AGENDA
Planning and Zoning Commission
April 16, 2025 – REGULAR MEETING
5:30 PM

Meeting Date:	April 16, 2025	Meeting Title:	Planning Commission
Submitting Department:	Planning Department	Presenter:	Tyler Valentine
Agenda Item:	Three Development Plans for Lots 53, 57, & 58 within the Snow King Master Plan (P24-168, P24-174 & P24-175)	Public Comment:	Yes

The applicant, Northworks Architects, is requesting approval for three Development Plans for the Snow King Condos on Lots 53, 57, & 58 that cumulatively total 240 guests (APOs), 110,897 sf of above-ground habitable, 175,876 sf total gross square footage (includes basements and non-habitable areas), 60 market short-term rental condominiums, and 12 affordable deed-restricted condominiums within four buildings that each have underground parking. Below is a summary of each lot:

Figure 1 - Proposed site plan overlayed on Master Site Plan

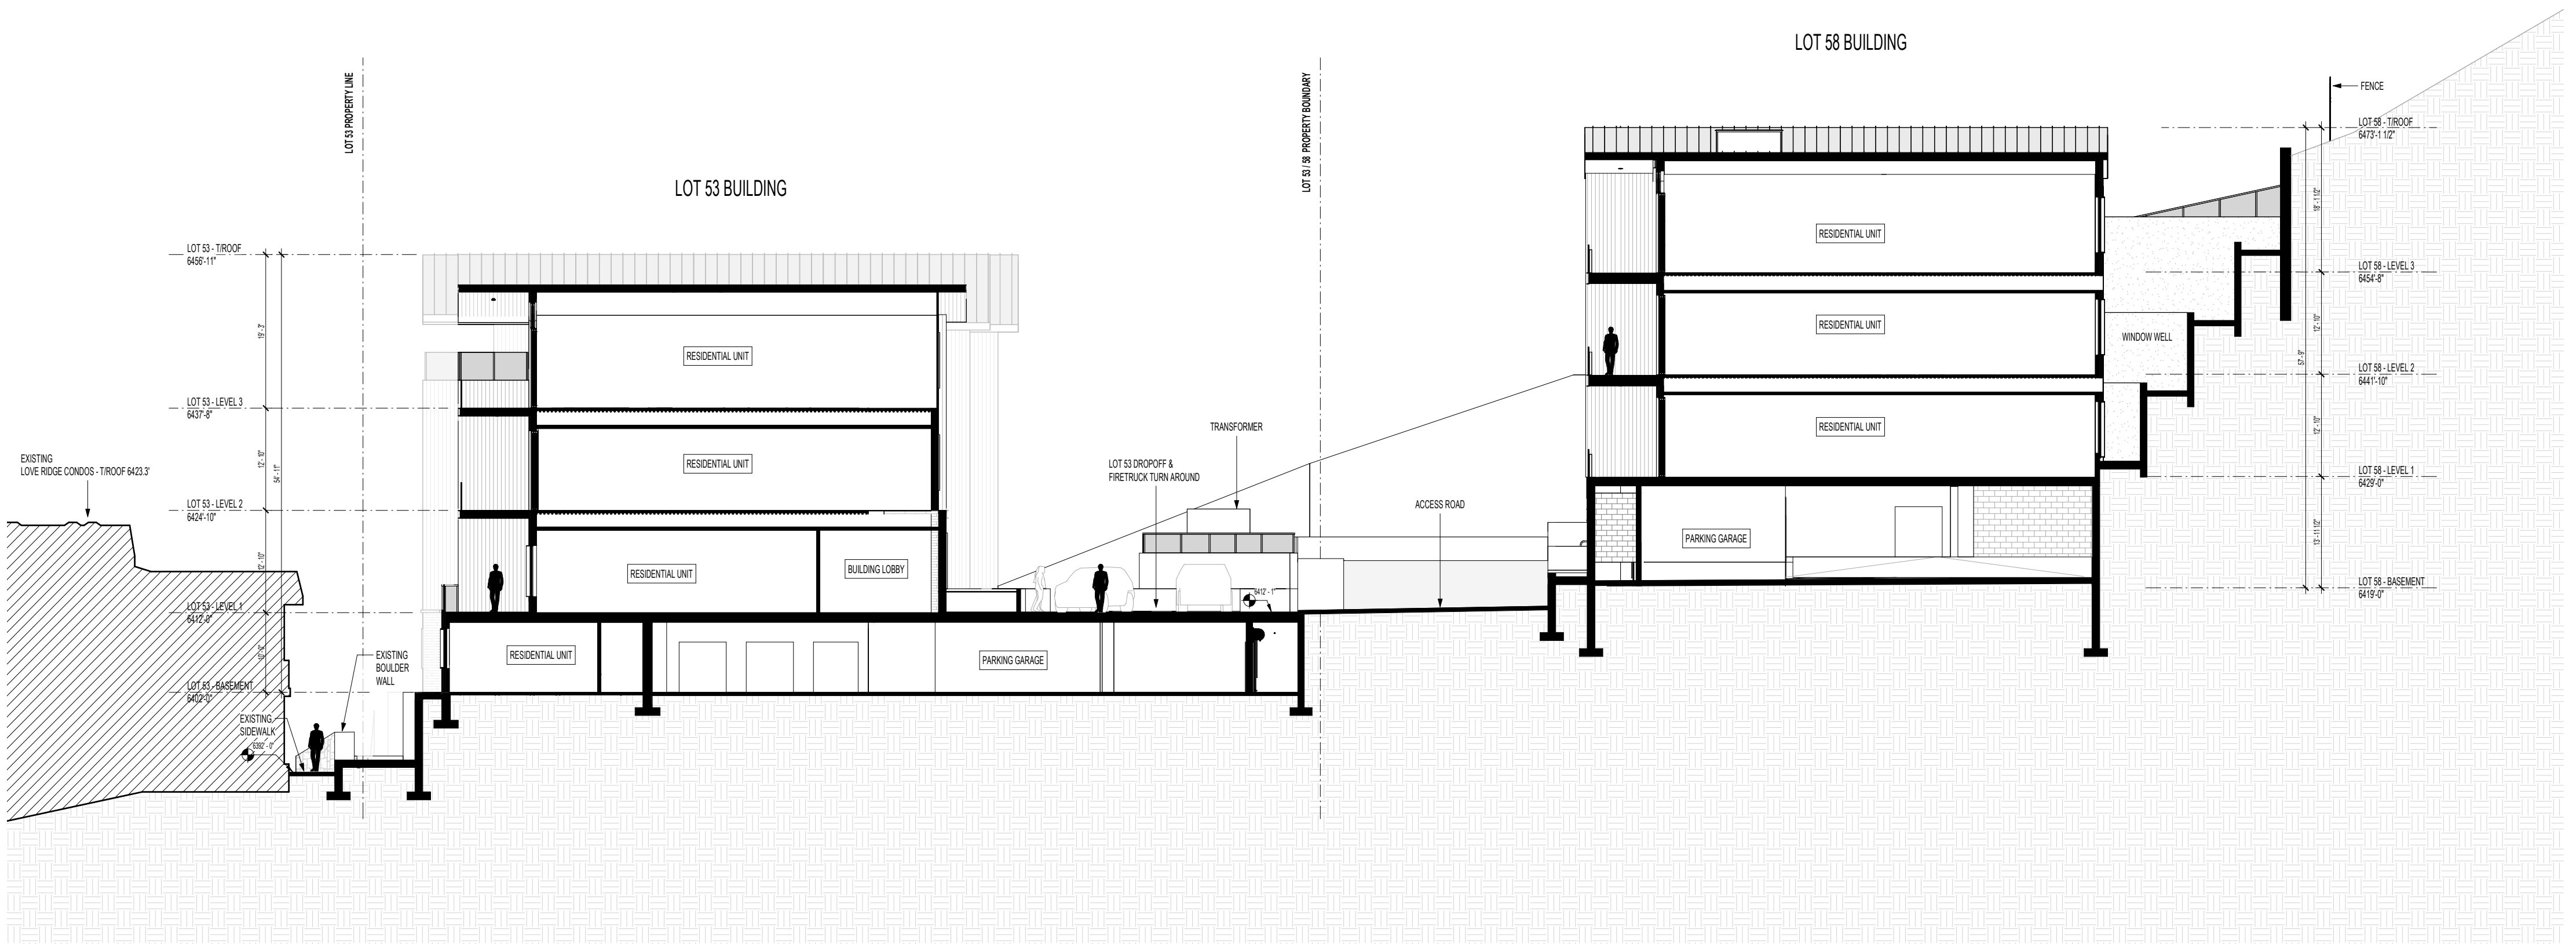
Of the three lots, staff finds that Lot 53 is most consistent with the conceptual Master Site Plan. The proposed basement footprint and upper levels include variations of push and pull along the north side of the building that are generally consistent with the building shown on the conceptual Master Site Plan. The push and pull help provide architectural breaks and relief, which are generally consistent with the architectural push and pull on the Love Ridge Condos to the north. Additionally, to address the transition between the existing Love Ridge Condos to the north, the proposed building provides space for adequate landscaping that will help minimize visual impacts to the extent possible. Overall, staff finds that Lot 53 is generally consistent with the conceptual Master Site Plan and finds that the proposed building location is appropriate for this lot.

Staff finds that the proposed building on Lot 58, which is located farther downhill (north) than the building shown on the conceptual Master Site Plan, is appropriate because Lot 58 is the steepest of the three lots and shifting the building farther downhill reduces hillside disturbance by decreasing the length of road needed to access it. The building shape is also more of a rectangle and better aligns with the contours of the hillside compared to the building shown in the conceptual Master Site Plan which is more of a square. Staff questions why the original building was shown so high up the hillside where the slopes are steepest, but as previously stated, the conceptual Master Site Plan was not intended to determine the exact location of future development. Additionally, shifting the building further downhill reduces visual impacts from adjacent

Amongst the three lots, Lot 57 deviates the most from the conceptual Master Site Plan, specifically because two buildings are proposed instead of one, and because the south building is pushed up against the southern property line and extends nearly to the eastern boundary, which is not explicitly prohibited but was not anticipated by the Master Plan. Although different from the conceptual Master Site Plan, this lot has no setbacks or limits on the number of buildings. The building shown for Lot 57 in the conceptual Master Site Plan illustrated one example of how a building could be situated, knowing it would need to step up the hillside and fit into the surrounding character. While stepping up the hillside can be accomplished in a single building design, multiple buildings can also accomplish the goal of stepping up the hillside, which is what the applicant has proposed. Page 86 of the applicant's submittal shows an east-looking section that demonstrates the stepping up the hillside with two buildings (visual provided below for reference). The proposed two-building plan also provides a visual break between the north and south buildings, allowing views and light to pass through the development from east to west.

LOT 57 MASTER PLAN VS. NEW PROPOSAL

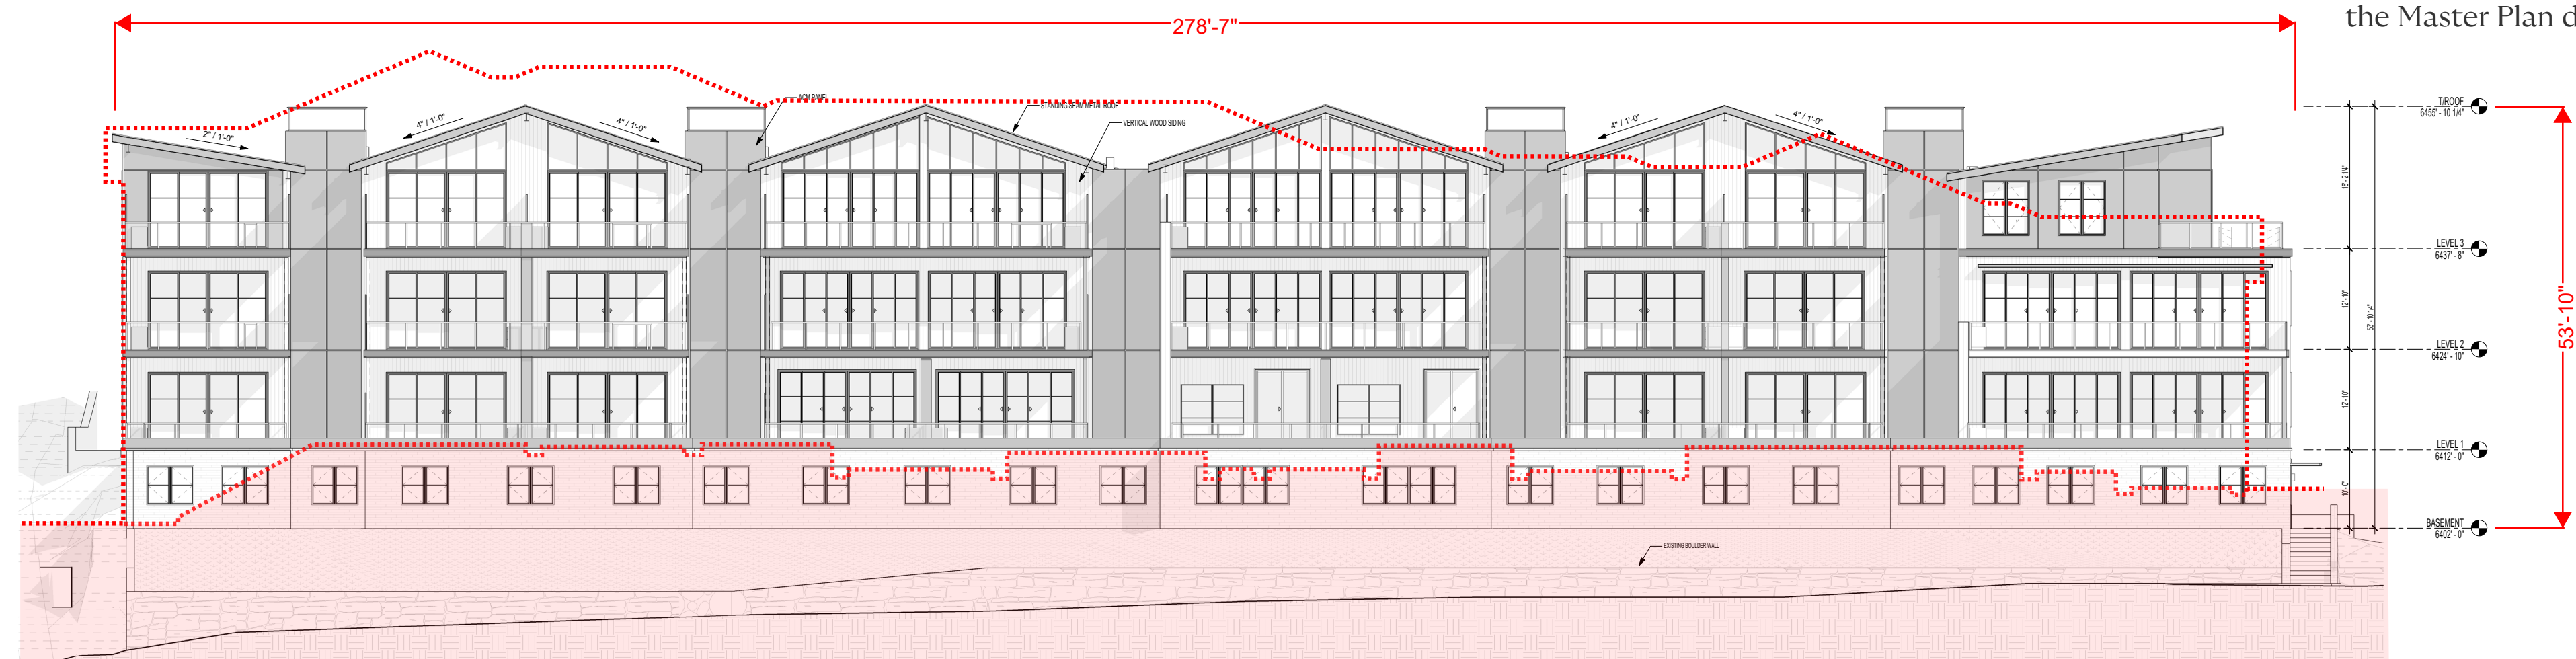
As previously mentioned above under the Master Site Plan section, staff have character-related concerns over the northeast portion of the south building because it is located close to the road and creates a canyon effect, which is more urban and not in character with surrounding developments that include adequate landscaping and space between the road the buildings. The cause of this canyon effect is because 1) the south building is proposed in a location that the Master Plan did not anticipate, but otherwise allows, and 2) the applicant is proposing more overall floor area and basement square footage on Lot 57 than shown on the conceptual site plan even though they are compliant with overall square footage, APOs, parking, FARs LSR, etc. The Master Plan Example Development Table and conceptual Master Site Plan contemplated a 25,393 sf habitable building over parking, and the applicant is proposing a total of 43,678 sf habitable, which is 18,285 sf larger. The additional habitable floor area on Lot 57 is a result of transferring over 10,000 sf from Lot 53, and over 5,000 sf from Lot 58, resulting in smaller buildings on Lot 53 & 58. In addition, +/-2,500 sf of additional floor area is proposed on Lot 57 that complies with the Master Plan's allowed FARs for this sub-area. Although the Master Plan does not

prohibit transferring floor area within the sub-area nor does it prohibit proposing more floor area than the Example Development Table and conceptual Master Site Plan, these transfers inadvertently create a larger development on Lot 57 and are contributing factors to staff's concerns over the south building needing to better fit in with the bulk, scale, and character of the existing surrounding development.

This canyon effect mentioned above can be mitigated through the use of additional landscape screening, modifications to the design and floor plans, reduced square footage or units, larger step-back on upper levels, and reducing roof overhang on the third level units. Staff have added a condition of approval requiring the applicant to make design and site plan changes prior to Town Council review that are geared at reducing the bulk and scale and improving the character of this section of the south building. This section of the building has also been the focus of concern from the adjacent neighbors, and thus the applicant will need to make changes to address these concerns related to neighborhood character and the pedestrian realm.

5. Prior to Town Council review, the applicant shall revise the site plan and landscape plan for Lot 57 to include additional landscaping and trees (at least 18' tall) in front of the northeast section of the south building and remove the vehicular turn-out and replace it with additional landscaping and trees (at least 18' tall). In addition, the applicant shall make design changes that further reduce the bulk and scale of the northeast corner of the south building. Suggested changes could include, but are not limited to, removing a section of building on the east side, shifting the building farther south, removing a partial story, shortening the roof overhang above the easternmost third-floor unit, reducing square footage, modifying the floor plans to create larger step-backs on upper units, and/or reducing unit counts.
